SERVICE BULLETIN

APPLICABILITY: 2026MY Outback
2026MY Forester

NUMBER: 17-22-26

SUBJECT: Passenger Seat Position Sensor Elimination /
Parts Compatibility and Service Guidance

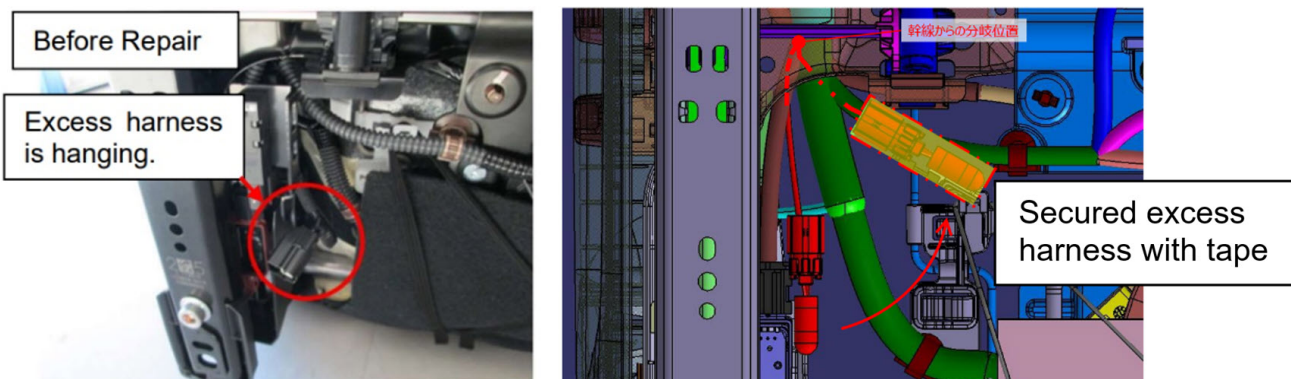
When replacing certain passenger seat components on vehicles produced from **March 16, 2026, through April 24, 2026**, or within the applicable VIN range listed above, the replacement component may be equipped with seat position sensor wiring even though a seat position sensor is not installed. To prevent rattles, secure the unused connector to the harness as shown below.

Locate the seat position sensor connector. Wrap the connector with foam tape and secure it to the seat frame to prevent it from contacting other components and causing a rattle noise.
